### **Hume Coal Project**

## Department of Industry (Water) additional technical advice to the Independent Planning Commission (IPC) about the Hume Coal Project

17<sup>th</sup> April 2019

**Figure 1 - Figure 5.1 of GEOTLCOV25281AB-ACA, Hume Coal Project, Groundwater Assessment Volume 1: Data Analysis 17 November 2016. Note red arrows and boxes added by Dol Water.**

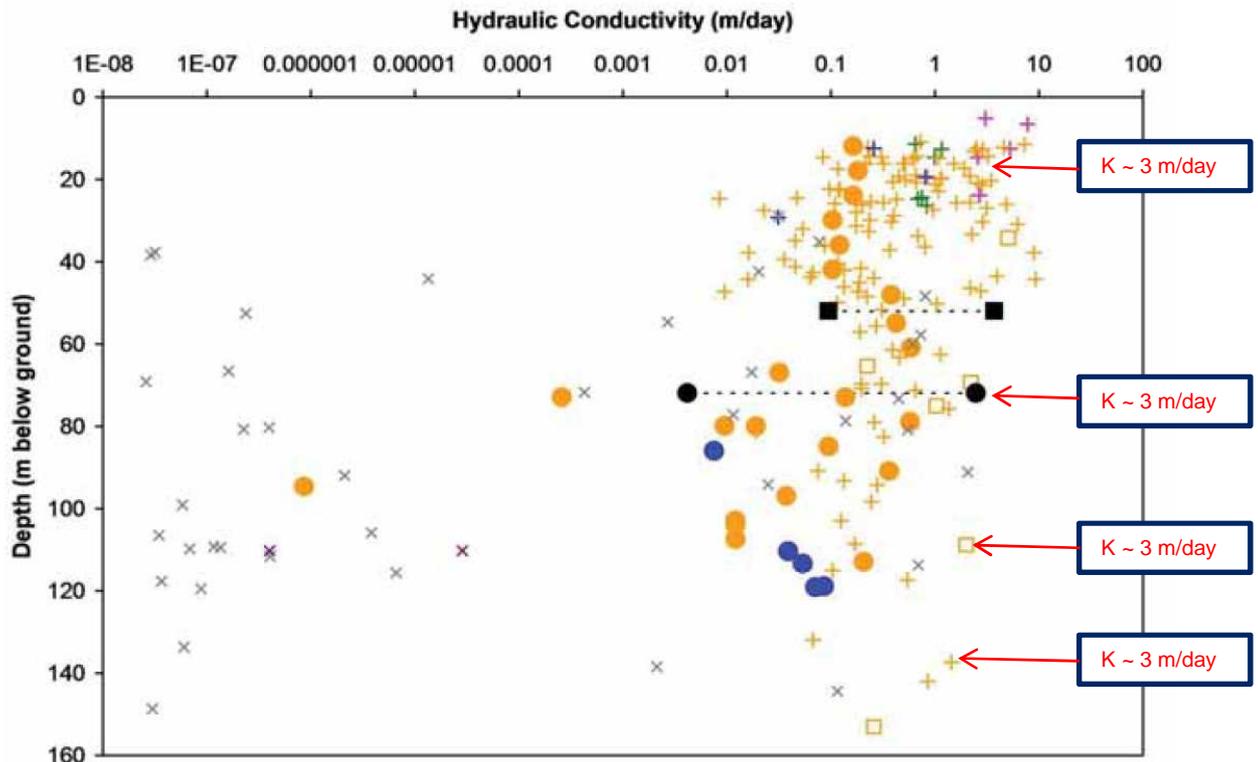
Attention is drawn to Figure 4.5 of GEOTLCOV25281AB-ACB plus Figures 5.1 and 5.2 of GEOTLCOV25281AB-ACA. It is clearly observed that predominantly in the Hawkesbury Sandstone (but also in the Basalts, Wianamatta Group and Wongawilli seam):

- K values in the range 0.01 – 5 m/day occur to depths of between 120 - 160 m and are numerous.

- The data presented by the proponent does not demonstrate clear field evidence for the assertion that hydraulic conductivity decreases with depth. In contrast as demonstrated in the above figure, conductivity remains high at depth. The upper range values are of approximately 3 m/day occurring to depths of 140 m.
- The linear regression as applied by the proponents modelling consultant to prove a decrease of hydraulic conductivity with depth is in the opinion of Dol Water an unreasonable and inappropriate fit of the data.

Dol Water highlights that  $K_v$  and  $K_h$  values used in the model and also in the uncertainty analysis and sensitivity testing did not adequately range over the field values with depth. A model must reasonably represent field values, including with depth, and in this case the model clearly falls short of demonstrating this.
